Product Change Notification

Date Issued :	August 31, 2026	**PCN Number :**	518601
Reason for Change :	Packaging Method/Quantity Change		
PCN Subcategory:	PCQC - Packing Size & Shape Change (Non DU Change)		
Description of Change :	This notification is to inform you about part(s) listed will undergo changes for packaging size/ packaging specification change. No changes will be made to product as part of this change.		
Reason for Short Notice :	Special Request		
Assessment of Change :	First Article Inspection Drop Test		
Planned Implementation Date :	October 01, 2026		
Customer Sample Availability Date:	September 26, 2026

55932 Series (2–5 Circuits): Packaging Tray and Other Changes

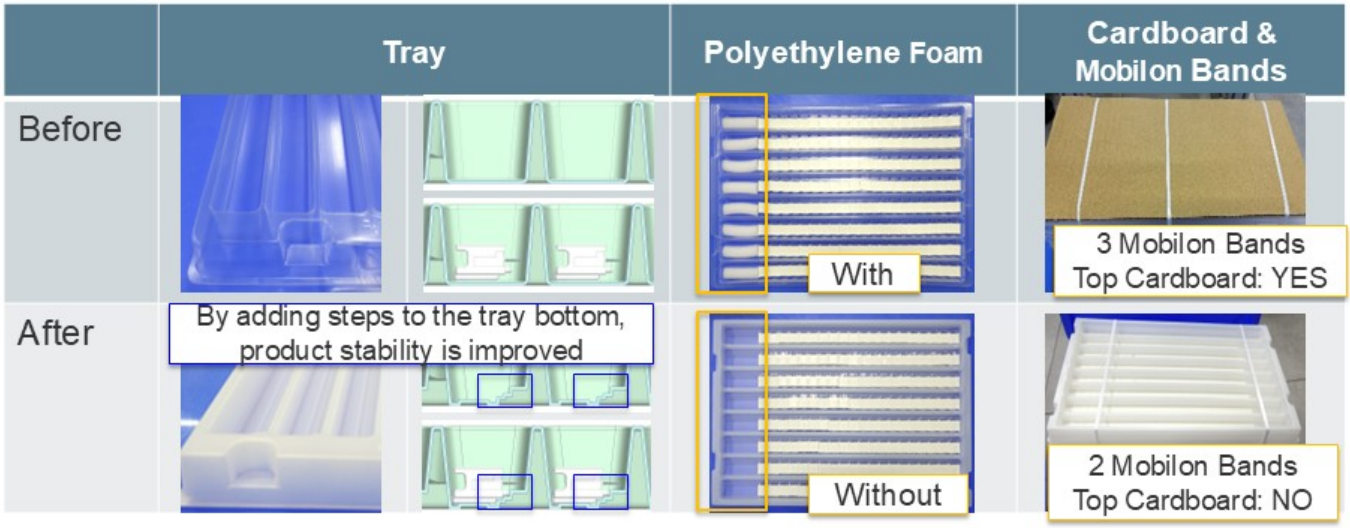
1. The tray shape: The tray shape will be changed as shown in the photo.
2. The polyethylene foam: The polyethylene foam will be removed.
3. Securing method: The securing method will be changed as follows:
   - Before: Cardboard on both the top and bottom, secured with three Mobilon bands.
   - After: Cardboard on the bottom only, secured with two Mobilon bands.

- **Reason for the Change:**
  The current tray does not fit the shape of the product and requires polyethylene foam to fill the gaps. Changing to a tray that matches the product shape will help ensure product stability during transportation. It will also reduce the use of packaging materials, such as polyethylene foam, and help address anticipated supply shortages.
- **Product Impact:**
  - There is no impact on the form, fit or function of the products.
  - The products may slide slightly within the tray after the polyethylene foam is removed. However, no issues were observed during the drop test with the products packed in the tray, confirming that the new tray and packaging configuration are acceptable.
- **PPAP and samples available upon request**
